Installation Engineering Handbook 269
Western Electric
Northern Illinois Works

TM 5.084
Dated: 4/01/81
Expiration Date 1/01/82

TEMPORARY MEMORANDUM
FOR NO. 3 ESS
REPAIR OF DEFECTIVE SOLDER
CONNECTIONS ON FB372
JUNCTOR CIRCUIT PACKS

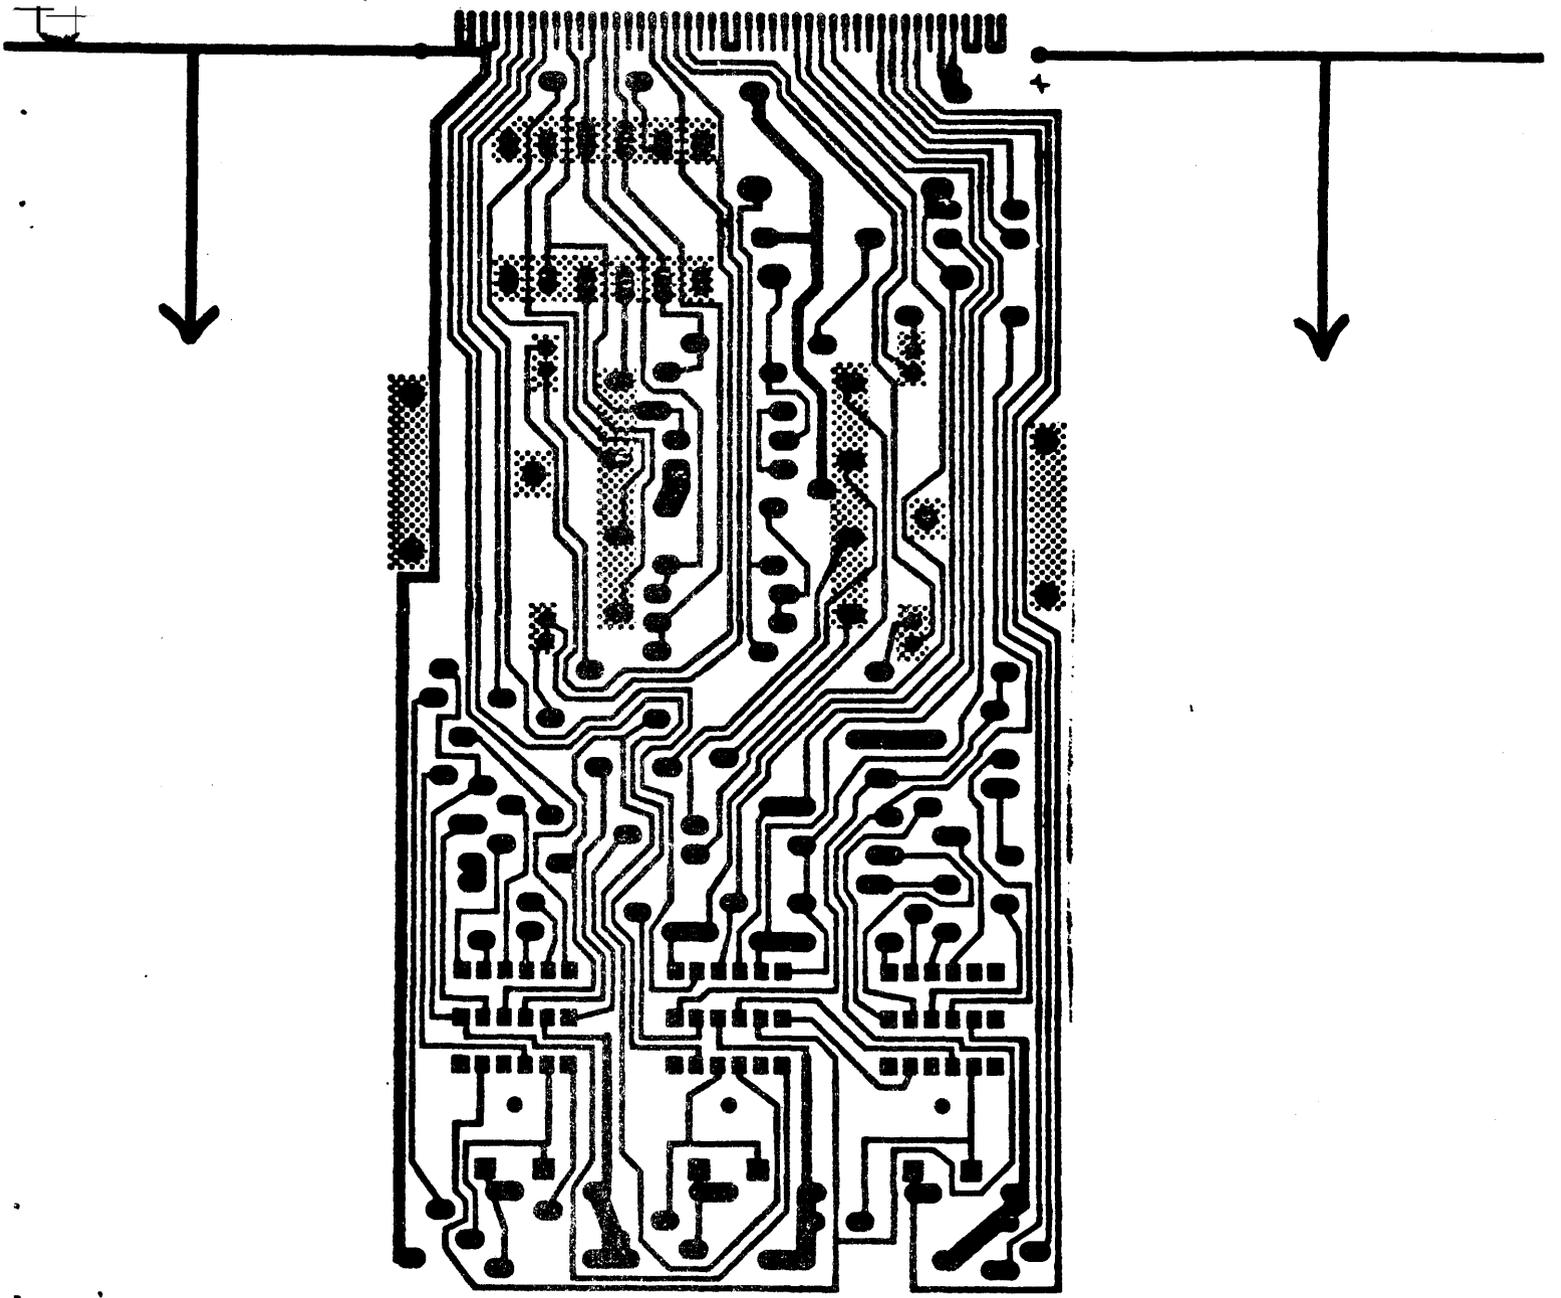
1.3 Specific instructions as to which components are to be resoldered are given in the template attached to this TM as Appendix A.

3.1 Refer to the template. All connections below the dotted line are to be resoldered.

3.34 Verify that all terminals of all components specified on the template for the junctor being repaired have been soldered.

3.4 To show that the junctor has been repaired according to procedures outlined in this TM, stamp 3/16-inch black plus sign (+) on the middle BF59 relay (K-2) coil so the plus sign is viewable when the pack is in service.

3.2 Carefully heat the terminals and add enough solder to the connection to obtain a satisfactory fillet of solder surrounding the entire terminal. It should not be necessary to heat the terminal more than 3-4 seconds. Remember that applying too much heat to the terminal will overheat the printed wire land area and destroy its adhesive bond to the board or cause internal damage to the component.

3.31 Verify that the solder has wetted the terminal and land area, that it has flowed smoothly, and that it has a shiny appearance. A lumpy, uneven connection indicates that too little heat was applied. A dull gray crystalline appearance indicates that too much heat was applied.

3.32 Verify that the solder connection does not extend more than 1/16-inch above the surface of the board.

3.33 Verify that there are no solder bridges between the resoldered land areas.
